YAMAHA MOTOR CORPORATION, U.S.A.

SAFETY RECALL NOTICE

August 30, 2010

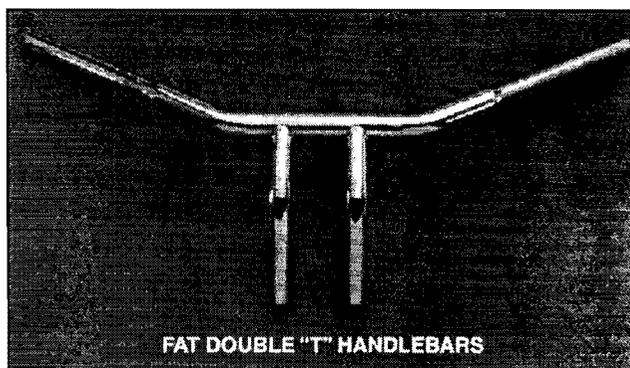
Due to a manufacturing error, Fat Double "T" Handlebars manufactured from August 1, 2008, through July 31, 2009, may have tubing thinner than designed where the bars narrow for the switch housings and grips. The affected handlebars could be weak enough in this area to break. If breakage occurs while the motorcycle is being ridden, the operator could lose control of the motorcycle which could result in a crash with injury or death.

If you have Fat Double "T" Handlebars as shown to the right on your Warrior or Road Star model motorcycle, you may be affected by this campaign. If you do not have accessory Fat Double "T" Handlebars or if you have ones that look similar but were not manufactured by Yamaha, you may disregard this letter.

Your dealer will look at the transition from the 1-inch diameter hand grip area to the 1-1/4-inch main crossbar. If there is a sharp line transition, the bars must be replaced. The inspection and, if necessary, installation of new handlebars will be at no cost to you for parts or labor.

Affected genuine Yamaha Fat Double "T" accessory handlebars must be replaced with new ones that have the correct tube thickness.
